Item ID: D206-781-041 Accept ***N900040100*** Setup Start ***NS1***
Revision ID: Stop ***NS2***
Item Name: Baggage Compartment Protector - Wall
Start Date: 4/19/2017 Start Qty: 5.00 ***5*** Cust Item ID:
Required Date: 4/25/2017 Req'd Qty: 5.00 ***5*** Customer:
Reference: SCHEDULED/C

DART SERVICE INSTRUCTION

TO AMEND INSTALLATION INSTRUCTIONS IIN-D407-781-2 REV. A OR LATER APPROVED REVISION
AND INSTRUCTIONS FOR CONTINUED AIRWORTHINESS ICA-D407-781 REV. 3 OR LATER REVISION

A	NEW ISSUE		13.04.08
REV.		DESCRIPTION	BY DATE
DESIGN			
DRAWN			
CHECKED			
MFG. APPR.	N/A		
APPROVED			
DE APPR.			
DATE	13.04.08		
		DART AEROSPACE LTD HAWKESBURY, ONTARIO, CANADA	
		DRAWING NO. REV. A DSI 9649 SHEET 1 OF 2	
		TITLE SCALE ALTERNATE INSTALL NTS	
COPYRIGHT © 2013 BY DART AEROSPACE LTD. THIS DOCUMENT IS PRIVATE AND CONFIDENTIAL AND IS SUPPLIED ON THE EXPRESS CONDITION THAT IT IS NOT TO BE USED FOR ANY PURPOSE OR COPIED OR COMMUNICATED TO ANY OTHER PERSON WITHOUT WRITTEN PERMISSION FROM DART AEROSPACE LTD.

**FIGURE 1 - D3879-1 BAGGAGE COMPARTMENT WALL
PROTECTOR - ALTERNATE INSTALLATION**

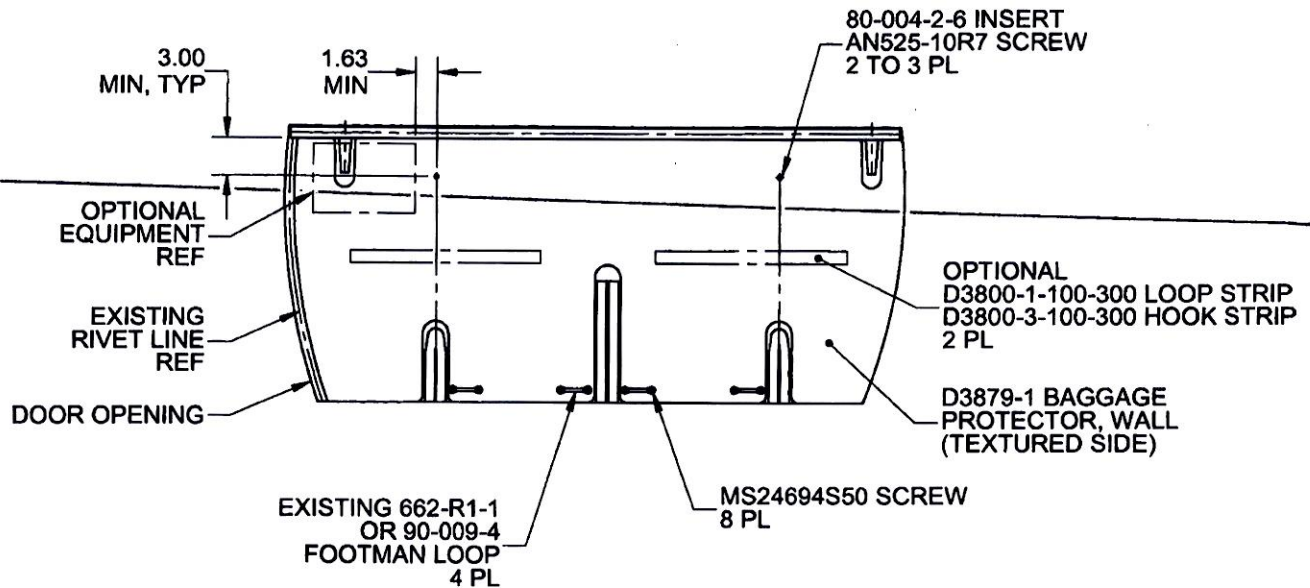
In some aircraft, the top portion of the D206-781-041 Baggage Compartment Wall Protector Kit cannot be installed as indicated in IIN-D407-781-2. The purpose of this DSI is to provide an alternate mounting method to fasten the top portion of the D206-781-041 Baggage Compartment Wall Protector Kit.

It is acceptable to replace qty(2) D3930-1 Clips with qty(2) 80-004-2-6 Inserts. Locate and mark location of the two attachment holes on the baggage compartment wall as shown in Figure 1 of this service instruction. Install 80-004-2-6 Inserts at the marked locations in accordance with Section 3-2-12 of BHT-206-SRM-1. It is acceptable to trim the wall protectors to accommodate optional equipment or transfer attachment holes to the wall protector and install the optional equipment on top of the wall protector with longer fasteners.

Amend the D206-781-041 Baggage Compartment Wall Protector Kit parts list as follows:

Qty -061	Qty -031	Qty -041	Part Number	Description
X			D206-781-061	BAGGAGE COMPARTMENT PROTECTOR KIT (FLOOR AND WALL)
1	X		D206-781-031	BAGGAGE COMPARTMENT FLOOR PROTECTOR KIT
1		X	D206-781-041	BAGGAGE COMPARTMENT WALL PROTECTOR KIT
		2	AN525-10R7	SCREW
		2	80-004-2-6	INSERT
